Title - Sujet First Stage In Situ Remediation	
Solicitation No. - N° de l'invitation EZ897-180850/A	Amendment No. - N° modif. 001
Client Reference No. - N° de référence du client	Date 2017-08-14
GETS Reference No. - N° de référence de SEAG PW-\$PWY-004-8128	
File No. - N° de dossier PWY-7-40138 (004)	CCC No./N° CCC - FMS No./N° VME
Solicitation Closes - L'invitation prend fin at - à 02:00 PM on - le 2017-08-23	Time Zone Fuseau horaire Pacific Daylight Saving Time PDT
F.O.B. - F.A.B. Plant-Usine: <input type="checkbox"/> Destination: <input checked="" type="checkbox"/> Other-Autre: <input type="checkbox"/>	
Address Enquiries to: - Adresser toutes questions à: Mestry, Ruth (PWY)	Buyer Id - Id de l'acheteur pwy004
Telephone No. - N° de téléphone (778) 995-4613 ()	FAX No. - N° de FAX (604) 775-6633
Destination - of Goods, Services, and Construction: Destination - des biens, services et construction: PWGSC - Muncho Lake & Fireside Maintenance Camps, km 698 & km 839 - Alaska Highway, BC

Maintenance Camp Insitu
Muncho Lake and Fireside Camp, Alaska Highway, B.C.

Addendum No. 1

DWN BY: PRT SCALE: 1:75 DATE: 2017-06-29 DWG No: REV.: 2
CHK'D: FG PLOT: 20170803.1456 CADFILE: 635031R18_800 **635031-805**

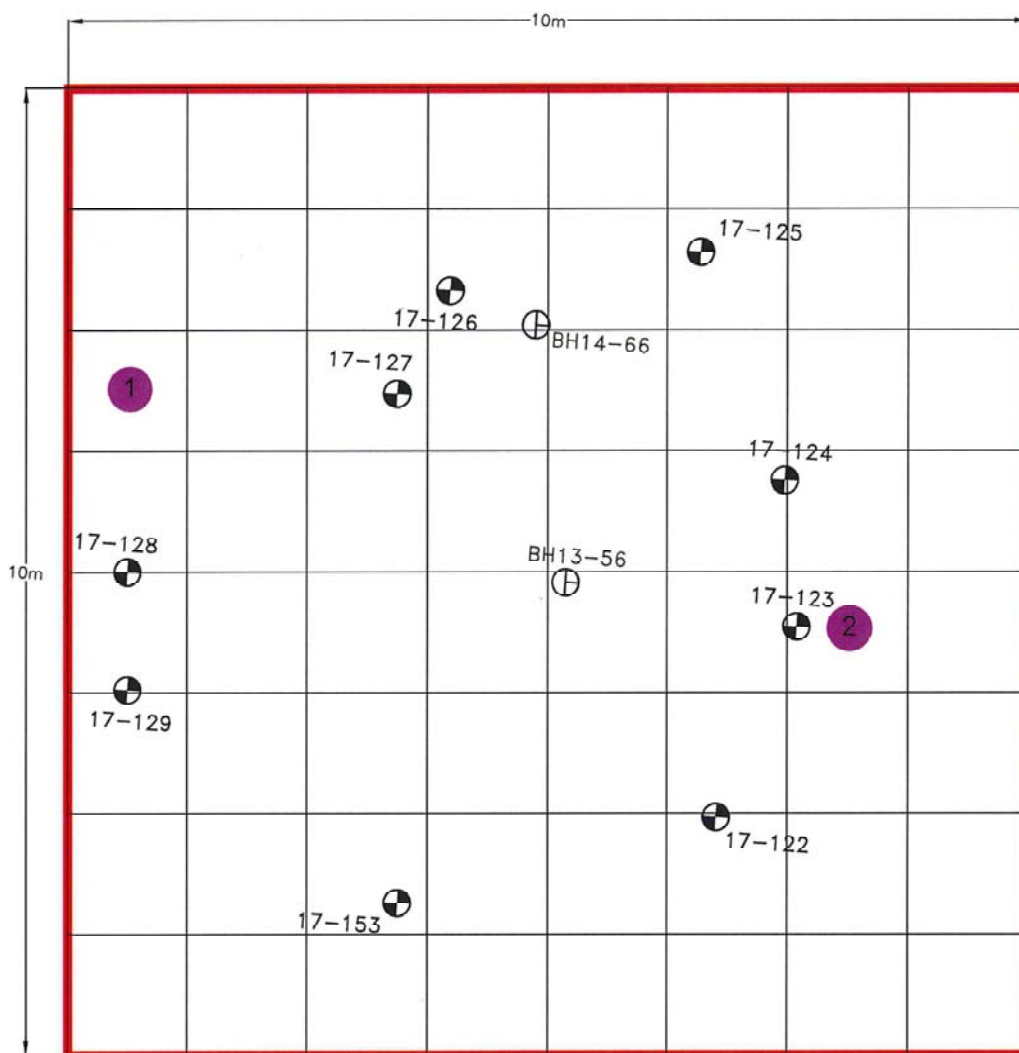
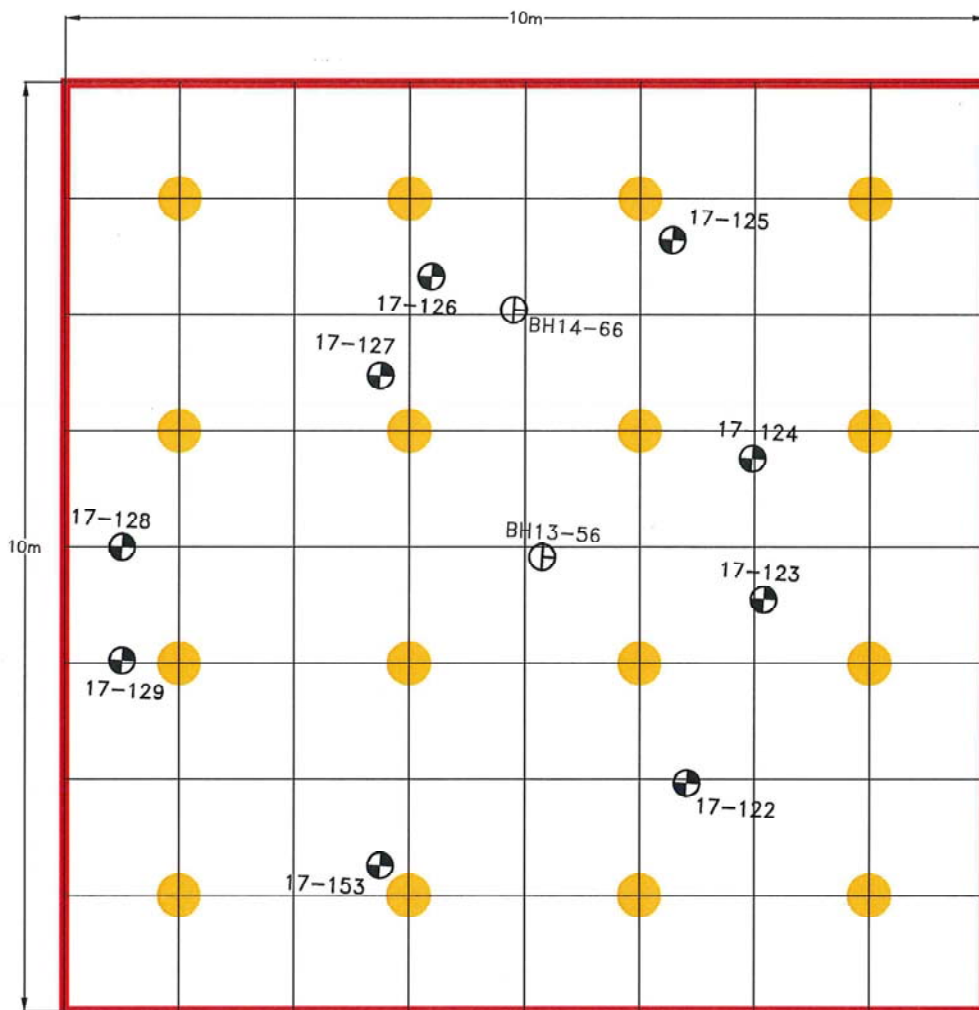
- Drawing 635031-805 – Notes 3 and 4 have been modified to indicate a solution of hydrogen peroxide, potassium citrate, and citric acid.
- Drawing 635031-806 – Drawing Title has been modified to indicate work as Optional Work.
- Drawing 635031-807 - Note 4 has been modified to indicate a solution of hydrogen peroxide, potassium citrate, and citric acid.
- Drawing 635031-810 - Note 4 has been modified to indicate a solution of hydrogen peroxide, potassium citrate, and citric acid.
